CITY OF PORTSMOUTH, NEW HAMPSHIRE
ADDENDUM NO. 2
To
PEIRCE ISLAND ROAD RESILIENCY PROJECT
BID NO. 08-24

The following changes and additional information are hereby made part of the Contract Documents.

Exhibit 2 - Test Pits

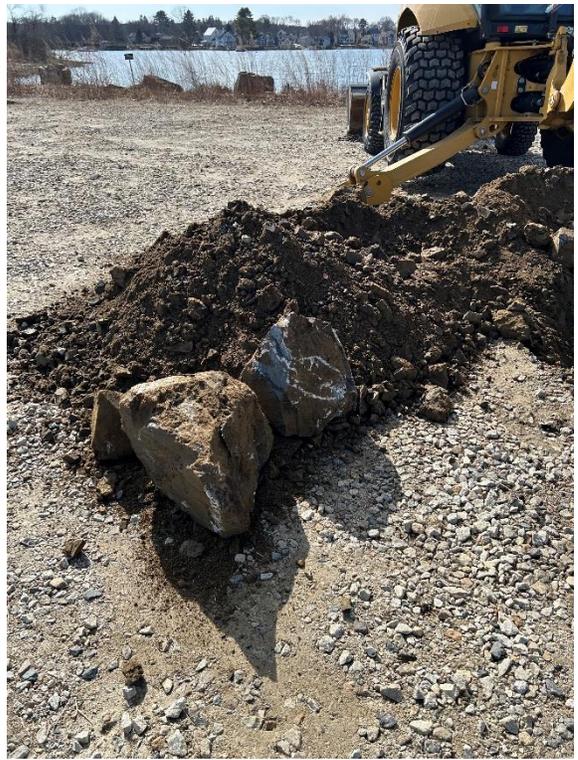
4. Test pits were conducted on February 22nd, 2024. Based on the 4 test pits evaluated, excessive amounts of loam, clay, muck, organics are not expected to be encountered. The existing subgrade material appears to be compacted broken ledge with gravel. Photos of the test pits and their respective locations are shown in Exhibit 2.

DISCIPLINE
 CIVIL
SHEET TITLE
 EDUCATIONAL SIGN DETAIL
SHEET NUMBER SK-001
 FEBRUARY 22, 2024

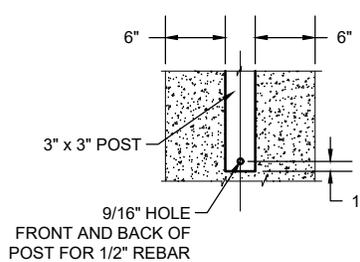
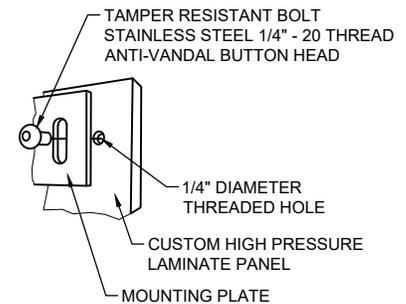
3. An installation detail for the Educational Signage referenced on Sheet 00 C-004 SITE PLAN is attached to this addendum. Details related to the size and content of the Educational Signage are included below and attached.

1. Add detail as shown on Sheet SK-001.

“2.01 EDUCATIONAL SIGN.

C. Size and thickness: Sign size should be 2'-3" W x 2'-0.9" H. Sign thickness should be ½" Custom High Pressure Laminate (CHPL) Panel.

1. Sign: Custom High Pressure Laminate (CHPL) suitable for outdoor installation
2. Single 3" x 3" Black Powder Coated Aluminum Post and 12" x 12" x 3/16" Plate.
3. In-Ground Mount.

4. (4) 316 Stainless Steel Threaded Inserts w/ 316 Stainless Steel Tamper Resistant Bolts.

F. Install per manufacturer's recommendations and in accordance with the installation details shown on the plans."
